# HISTORIC AND DESIGN REVIEW COMPLIANCE & TECHNICAL ADVISORY BOARD

<b>HDRC CASE NO:</b>	<b>2024-153</b>
<b>ADDRESS:</b>	126 BEVERLY DR
<b>LEGAL DESCRIPTION:</b>	NCB 9077 BLK LOT E 22 FT OF 4 & W 55 FT OF 5
<b>ZONING:</b>	R-6, H
<b>CITY COUNCIL DIST.:</b>	7
<b>DISTRICT:</b>	Monticello Park Historic District
<b>APPLICANT:</b>	Jamie Mathis/MATHIS JAMIE MARGARET
<b>OWNER:</b>	Jamie Mathis /MATHIS JAMIE MARGARET
<b>TYPE OF WORK:</b>	Construction of a carport
<b>APPLICATION RECEIVED:</b>	March 28, 2024
<b>60-DAY REVIEW:</b>	May 27, 2024
<b>CASE MANAGER:</b>	Jessica Anderson

The applicant requests a Certificate of Appropriateness for approval to install a 22'x22' metal carport.

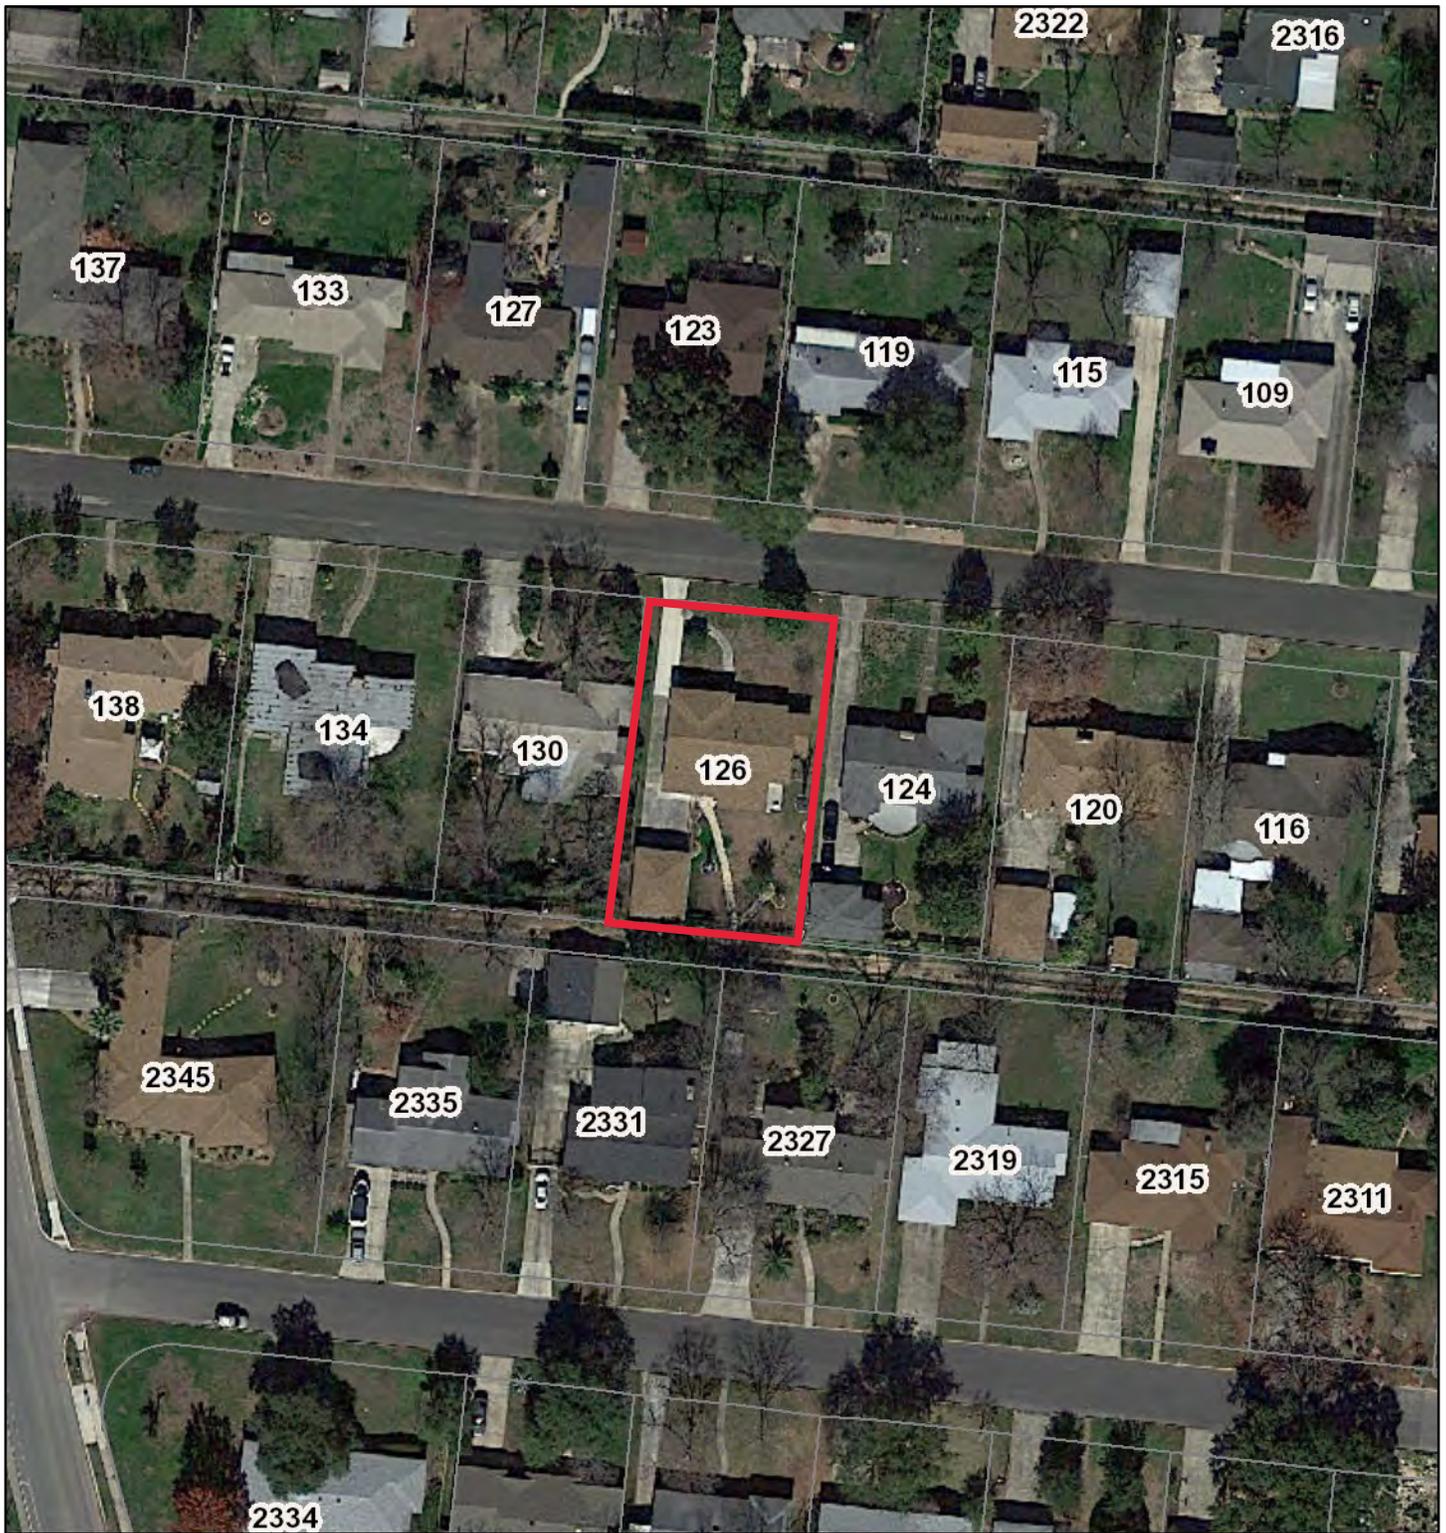
- c. CARPORT: The applicant requests approval to construct a 22'x22' front-gabled metal carport that is 9' tall at the sides and 11' at the peak of the gable. The height of the carport appears to exceed the height of the existing detached garage. The Guidelines for New Construction 5.A. notes that new garages and outbuildings should be visually subordinate to the primary historic structure in terms of their height, massing, and form, and should be no larger in plan than forty percent of the primary historic structure's footprint. The existing one-story primary structure on the lot features a footprint of 2,049 square feet, including two open attached porches, with a 520-square-foot detached garage, bringing the total lot coverage to 2,569 square feet. The carport has a total footprint of 484 square feet, or approximately 24% of the primary structure's footprint. Staff finds the proposed footprint of the carport is generally appropriate, but that the overall height should be reduced so that it doesn't exceed the height of the existing detached garage.

- d. MATERIALS: The Guidelines for New Construction 5.A.iii and iv note that new accessory structures should relate to the period of construction of the primary historic structure on the lot through the use of complementary materials and simplified architectural details. The applicant proposes a fully metal carport with 5V metal roof. Staff finds the materials do not conform to guidelines, and that a wood frame would be more appropriate.

- i. That the applicant reduces the overall height of the carport so that it doesn't exceed the height of the existing detached garage, as noted in finding c.
- ii. That the applicant proposes a wood-framed or wood-clad frame for the carport, as noted in finding d.
- iii. That the applicant meets all setback standards as required by city zoning and obtain a variance from the Board of Adjustment if applicable.
